**From:**  
**Sent:** 27 June 2024 14:31  
**To:** Nick Hirst  
**Cc:** DCAdmin  
**Subject:** Planning Application 2024-91236 - Safety first?  
**Attachments:** safety\_first.pdf

Looking at the plans for plots 23, 34 and 35, I am not convinced it has been fully considered.

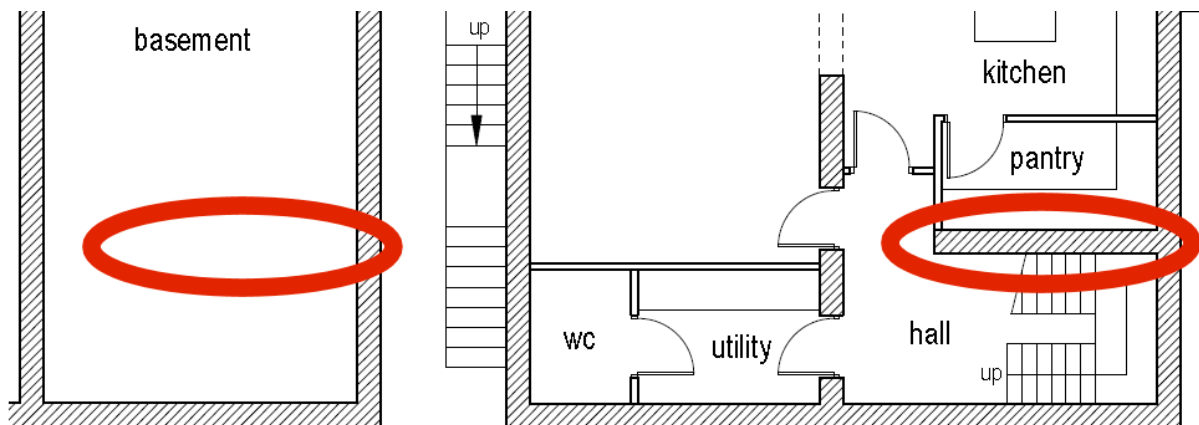
Within the plans submitted, the lower ground floor hall has load-bearing walls on all four sides: see 2024-91236\_+Grouped+Plans+and+Elevations\_1040042.PDF and 2024-91236\_+Grouped+Plans+and+Elevations\_1040043.PDF.

Below, in the basement, there are only three.

I expected to see a fourth, with *"an additional foundation trench"*.

With that fourth wall in place, the basement would, presumably, then show three rooms, not two.

The wall in question, and it's absence, have been highlighted, in the picture below:

If a load-bearing wall does not start at ground level, I understand a steel/concrete beam would be used, and indicated on the plan.

In fact, there is such a depiction, in the same plans, for a different part of the dwelling: *see right, highlighted in green.*

If the missing load-bearing wall has been overlooked, it is worrying.
